CR177 - Fuel tank and Owner's Manual updates Panigale V4 (all model versions, CAL and CND country versions) Safety Recall Campaign SRV-RCL-19-001

Date: May 23, 2019
To: Dealer Principal, General Manager, Service Manager, North American Dealer Network
From: Richard Kenton, Technical Director
Eric Bradley, Technical Training and Publications Manager

2. Fuel tank adhesive label:

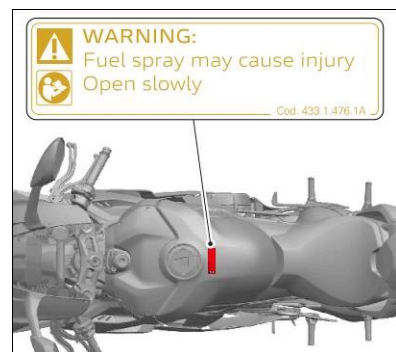
Fix the adhesive label that reads: "Warning: Fuel spray may cause injury, Open slowly" onto the fuel tank.

3. Adhesive page onto Owner's manual:

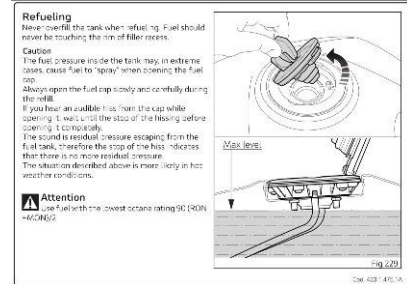
Apply the warning: "The fuel pressure inside the tank may, in extreme cases, cause fuel to "spray" when opening the fuel cap. Always open the fuel cap slowly and carefully during the refill. If you hear an audible hiss from the cap while opening it, wait until the stop of the hissing before opening it completely. The sound is residual pressure escaping from the fuel tank, therefore the stop of the hiss indicates that there is no more residual pressure. The situation described above is more likely in hot weather conditions."

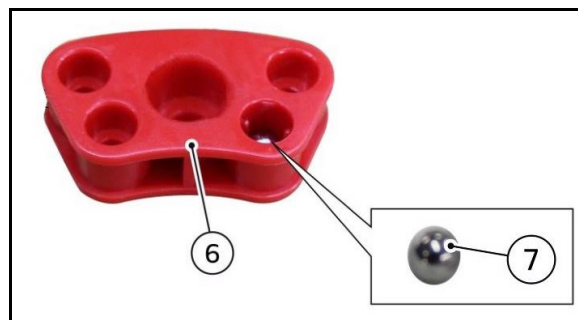
6. Remove the **ball (7)** from inside the **valve block (6)**

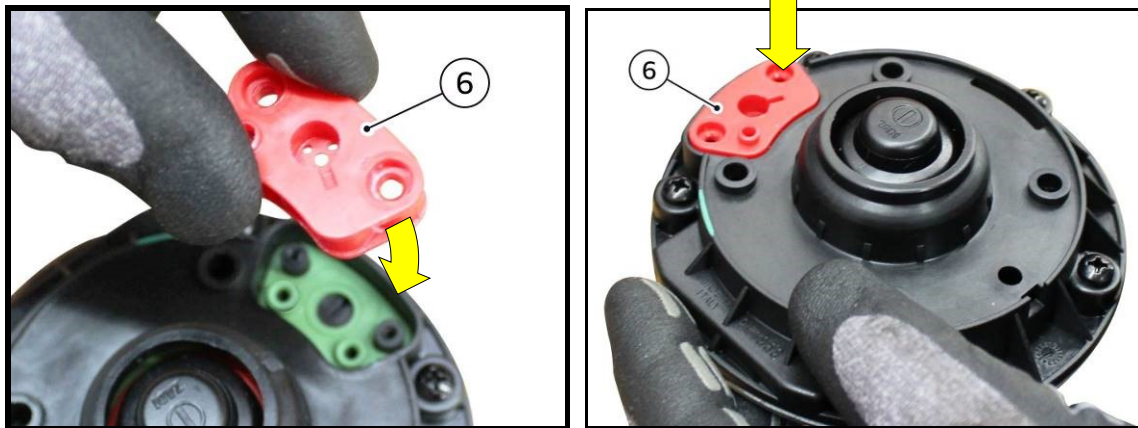
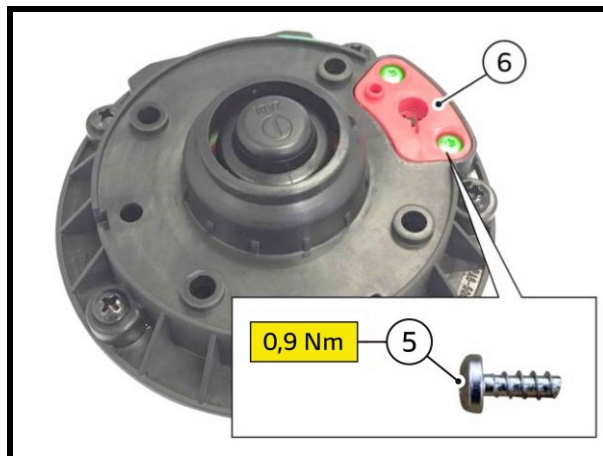
7. Install the **valve block (6)** on the filler plug placing it as shown in the figure.

Place the **valve block (6)** fully home, making sure that the valve system surface is aligned with the filler plug surface.

8. Tighten the **valve block (6)** fastening screws (5) to 0.9 Nm

Before tightening, ensure to start the **2 screws (5)** in the original threads already present.

Part 2: Fuel tank label

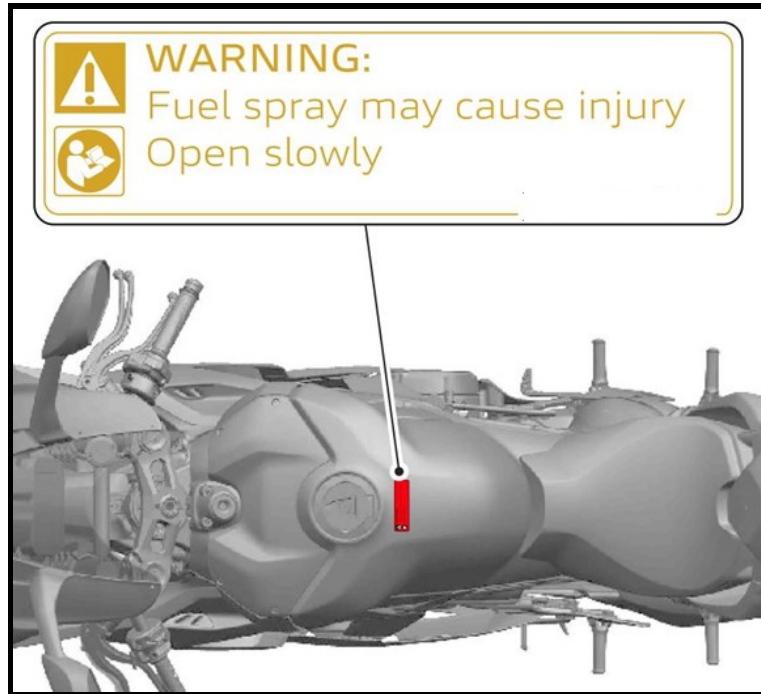
Apply the adhesive label that reads "Warning: Fuel spray may cause injury, Open slowly" on the fuel tank as shown in the figure.

Part 3: Owner's manual

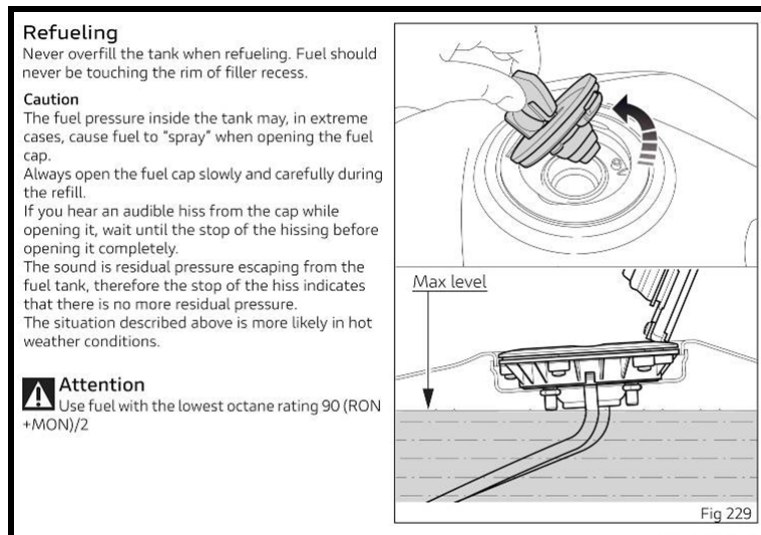
Apply the new warning adhesive page on the Owner's manual:

"The fuel pressure inside the tank may, in extreme cases, cause fuel to "spray" when opening the fuel cap. Always open the fuel cap slowly and carefully during the refill. If you hear an audible hiss from the cap while opening it, wait until the stop of the hissing before opening it completely. The sound is residual pressure escaping from the fuel tank, therefore the stop of the hiss indicates that there is no more residual pressure. The situation described above is more likely in hot weather conditions."

This adhesive page shall be applied on the Owner's manual pages listed below according to the model:

- page 285 for Panigale V4 Standard
- page 299 for Panigale V4 S
- page 301 for Panigale V4 Speciale
- page 305 for Panigale V4 R
